### Division of Water Rights

### DAM INSPECTION REPORT – 2012

Dam Name & Number	Northern Utah County – Tibble Fork, UT00299		
Date	July 12, 2012	Dam Type	Zoned Earthfill
Storage Level	6378.5ft MSL	Hazard Rating	High
Outlet Flow	0 c.f.s.	Purpose of Inspection	Annual Inspection
Spillway Flow	75 c.f.s.	Weather	Sunny & Clear, 68°F

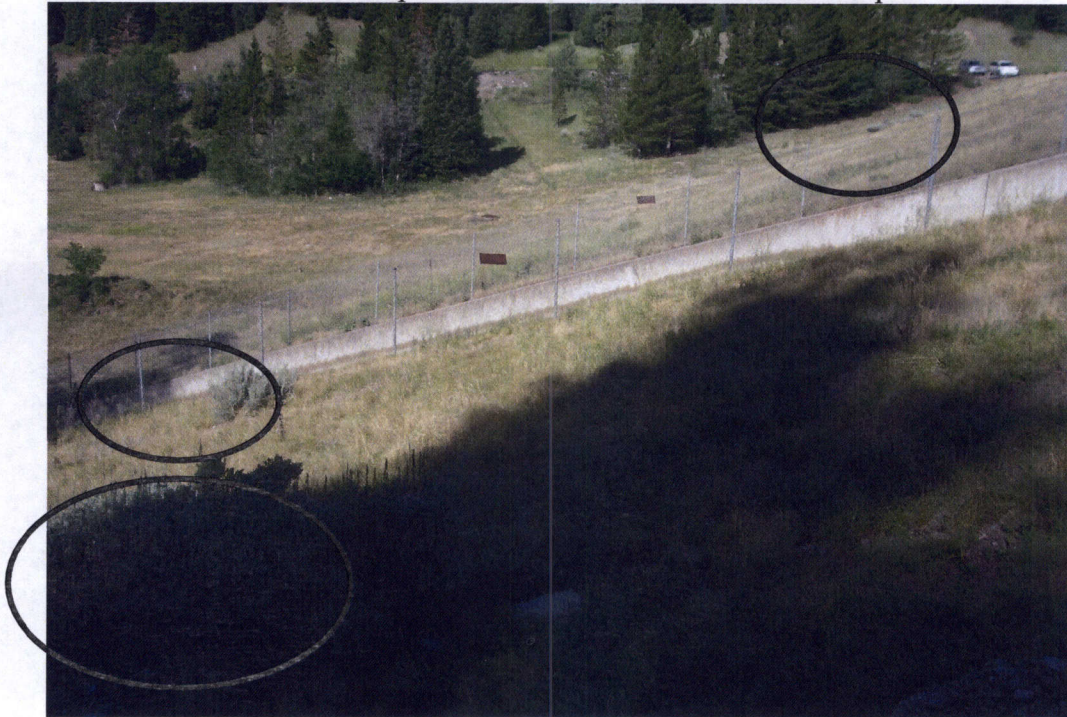
Checklist Item	Necessary Action, Maintenance and/or Repair:
2., 3.	Remove willows from the upstream slope to the right of the spillway intake. Remove sagebrush from the downstream slope. Exterminate burrowing rodents.

Photo 2: Example of rodent hole on downstream slope.
